**HISTORIC LANDMARK COMMISSION
FEBRUARY 27, 2012
CERTIFICATE OF APPROPRIATENESS
LHD-2012-0001
4314 Duval Street
Hyde Park Local Historic District**

Install insulation at front façade, replace non-historic windows, construct an approximately 350 sq. ft. rear addition and a two-story detached garage apartment.

EAST ELEVATION

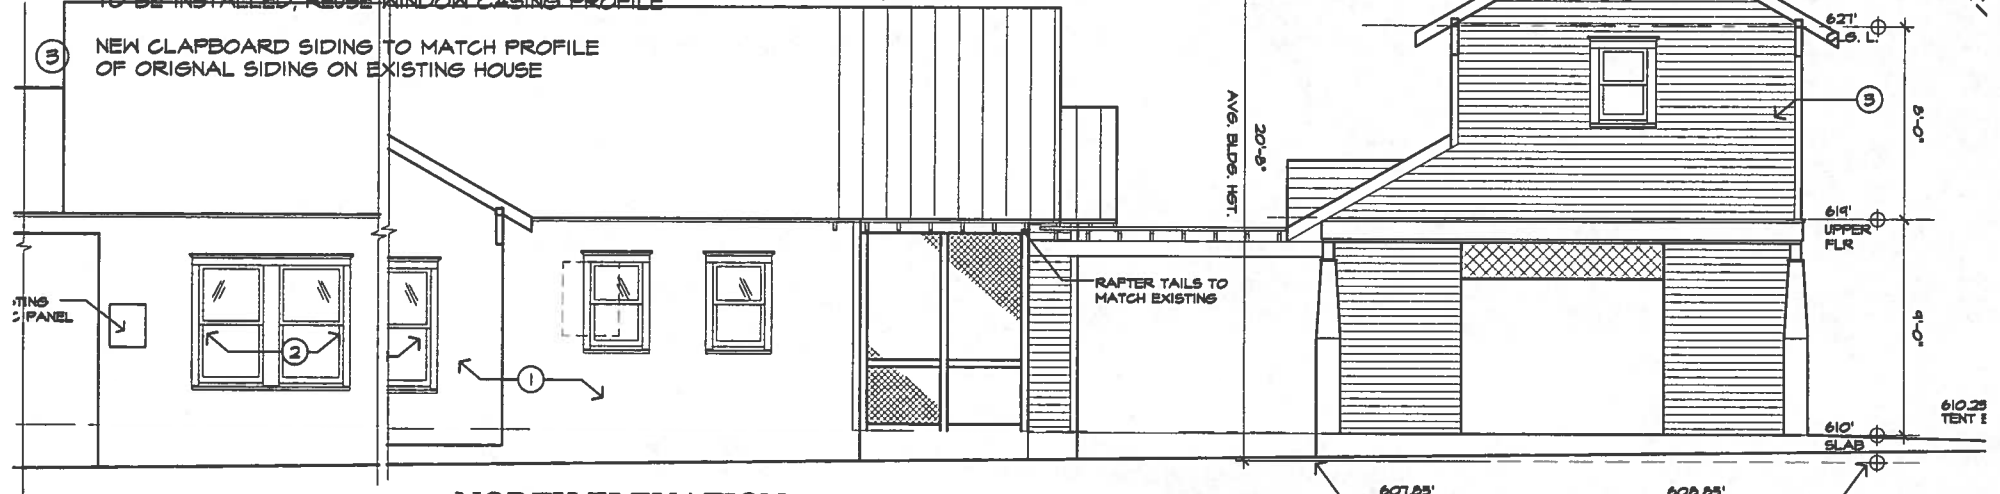
The project was reviewed at a Certificate of Appropriateness Review Committee meeting. The Committee felt the installation of insulation as proposed was appropriate as long as care is given to ensure the increased wall thickness has minimal visual impact. The Committee recommended retaining the window in the front gable end. The Committee had no comments related to the design of the rear addition or detached garage apartment.

Staff recommends approving the Certificate of Appropriateness as presented incorporating the Committee's recommendation to retain the gable end window.
